MS context release indication

Hyunjeong Kang, Sungjin Lee, Hyoung Kyu Lim, Jungje Son, Panyuh Joo
Samsung Electronics

Figure xx: Handover procedure involving RS with centralized HO control from MR-BS

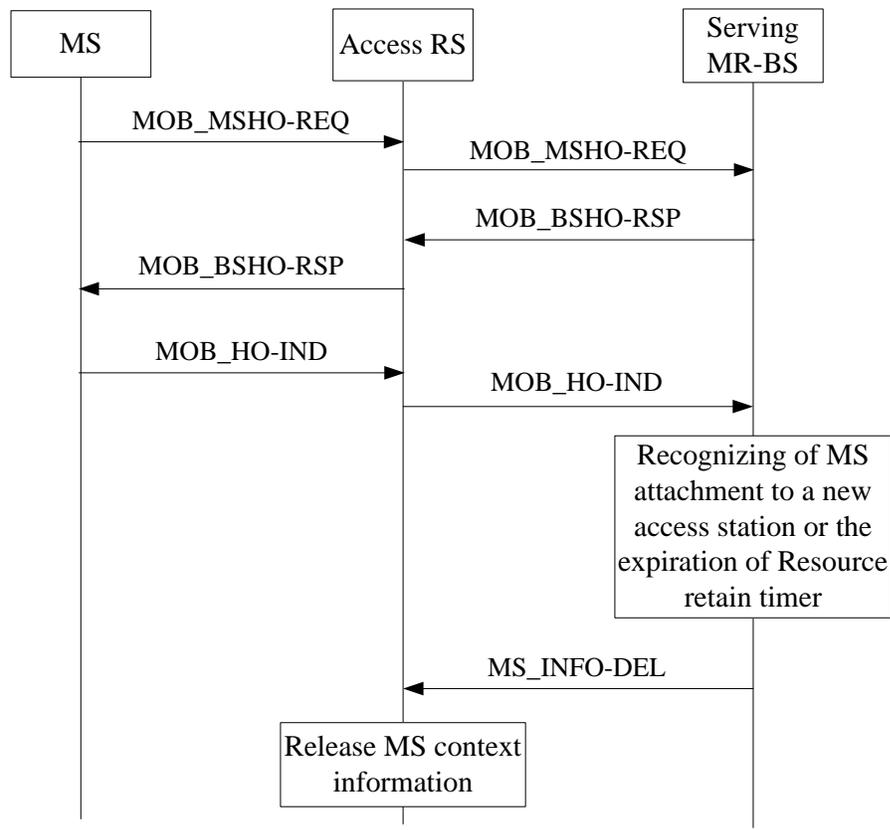
[Insert the followings at the end of section 6.3.22.5.1 in page 30]

If a serving MR-BS recognizes that MS attaches to a new access station or Resource retain timer expires, and the MS's old access station is an RS which is controlled by the MR-BS, the MR-BS may send the MS_INFO-DEL message to make the RS discard MS context information. Upon receiving the MS_INFO-DEL message, the RS shall remove the MS context information.
